522321

EP3 coated replacement spring (left side) for model 940 doors shipped from July 1995 to July 2000.

| THE DRAWING AND ALL DA | | |
|---|--|--|
| DATE 11/21/11 BY APP'D | SPRING, DOOR, LEFT, 1995-2000 | |

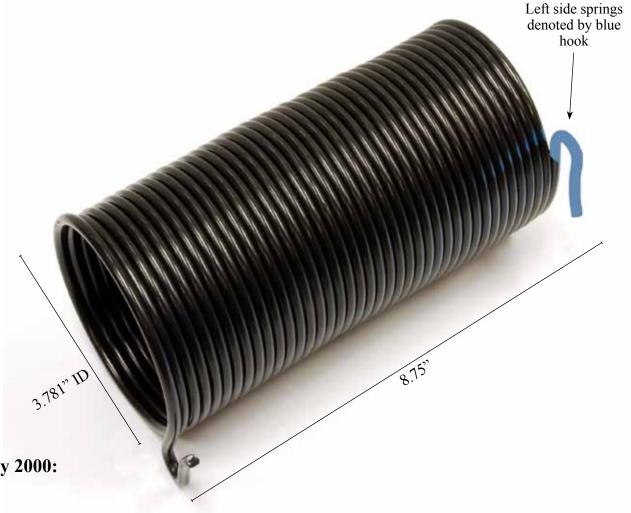
Due to product improvements, springs of different size and finish are specified for replacement in certain doors. To verify that this is the correct replacement for your application, consider the shipment date if known, and compare the original specification on the table below to the spring that you will be replacing.

Left/Right side is as observed when standing inside the storage unit looking out at the door. In standard Trac-Rite applications, the latch side is the left side.

For 940 doors shipped from July 1995 to July 2000:

Width range: 2'10" to 9'0" Height range: Up to 10'4"

| | Original Spring | Replacement Spring |
| Wire Diameter | .207" | .218" |
| Inside Diameter | 3" | 3.781" |
| Nominal Length | 8.69" | 8.75" |
| No. of Coils | 41 | 39 |
| Inch Number Per Turn (IPPT) | 41 | 43 |
